Work Order ID 98381

Item Name: Replacement Skidtube

DESIGN	DRAWN BY	DART AEROSPACE USA, INC.
CP	PH	PORT HADLOCK, WA
CHECKED	APPROVED	DRAWING NO. / REV.
		D3274 / D
DATE		TITLE / SCALE
06.12.19		SKIDTUBE ASSEMBLY / NTS

DRAWING NO.	TITLE	REV. D	DART AEROSPACE USA, INC	D.E.O. NO.	SHEET NO.	SCALE
D3274	SKIDTUBE ASSEMBLY		ENGINEERING ORDER	D3274-D-1	SHEET 1 OF 1	NTS

DETAIL F: END FINISHING DETAIL

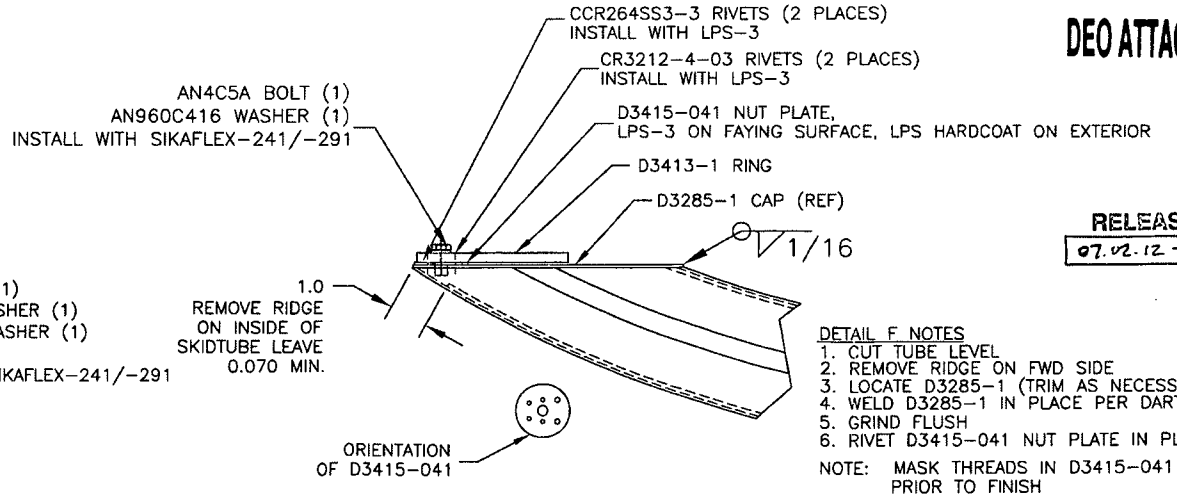
DEO ATTACHED

DETAIL F: END FINISHING DETAIL

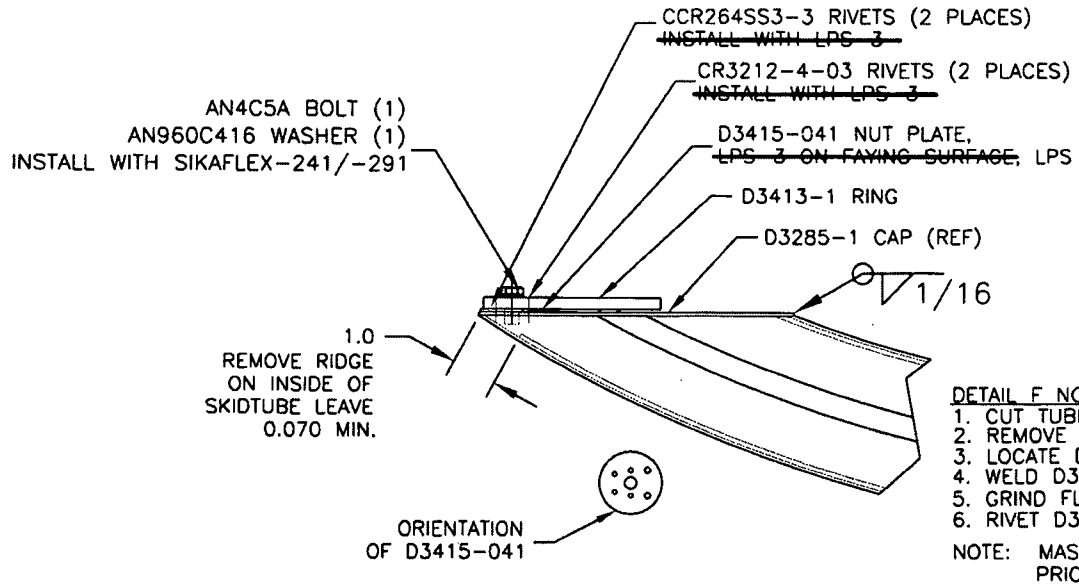
AMEND DETAIL F AS SHOWN:

DETAIL F NOTES
1. CUT TUBE LEVEL
2. REMOVE RIDGE ON FWD SIDE
3. LOCATE D3285-1 (TRIM AS NECESSARY)
4. WELD D3285-1 IN PLACE PER DART QSI 004
5. GRIND FLUSH
6. RIVET D3415-041 NUT PLATE IN PLACE
